RENESAS TECHNICAL UPDATE

Classification of Production	MPU			No	TN-SH7-478A/E	Rev	1
THEME	Correctional specs and additional specs concerning SH7750 electric characteristic tSTD Classification of Information		 Spec change Supplement of Documents Limitation of Use Change of Mask Change of Production Line 				
	SH7750/ SH7750S / SH7750R	Lot No.				Effective Date	
PRODUCT NAME		All	Reference Documents		0 Hardware Manual 02-124E Rev. 6.0	Е	Eternity

Figure 22.14 Pin Drive Timing for Standby Mode

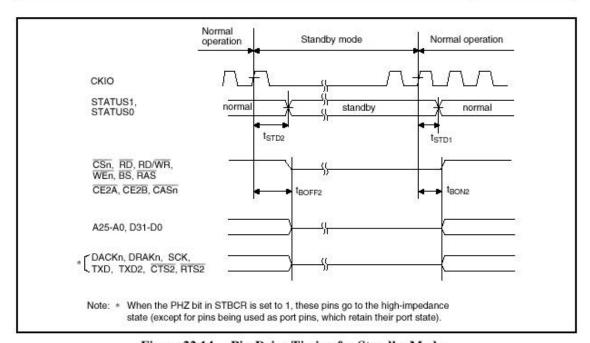
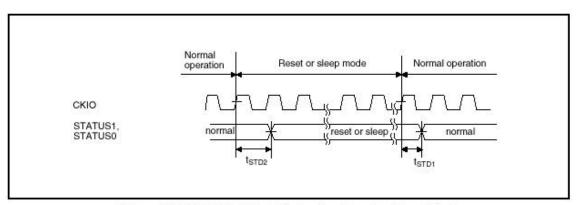
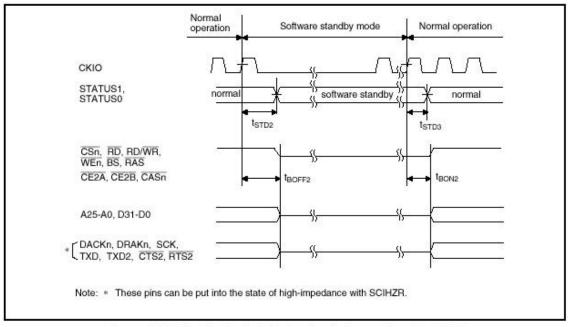
This is to notify you of the correction and the addition of the pin drive timing at following table 22.34 and 22.35 control signal timing and figure 22.14 standby mode for output delay time (tSTD) of electric characteristic STATUS pins of SH7750.

Item	Symbol	Min.	Max.	Unit	Figure
Bus tri-state delay time to standby mode	t _{BOFF2}	-	2	t _{oyo}	22.14(2)
Bus buffer on time	t _{BON1}	_	12	ns	22.13
Bus buffer on time from standby	t _{BON2}	_	2	t _{oyo}	22.14(2)
STATUS 0/1 delay time	t _{sm}	_	6	ns	22.14(1)
	t _{stoe}	\rightarrow	2	t _{cyc}	22.14(1)(2)
	t _{smos}	-	2	t _{cyc}	22.14(2)

Figure 22.14(1) Pin Drive Timing for Reset or Sleep Mode

Figure 22.14(2) Pin Drive Timing for Software Standby Mode
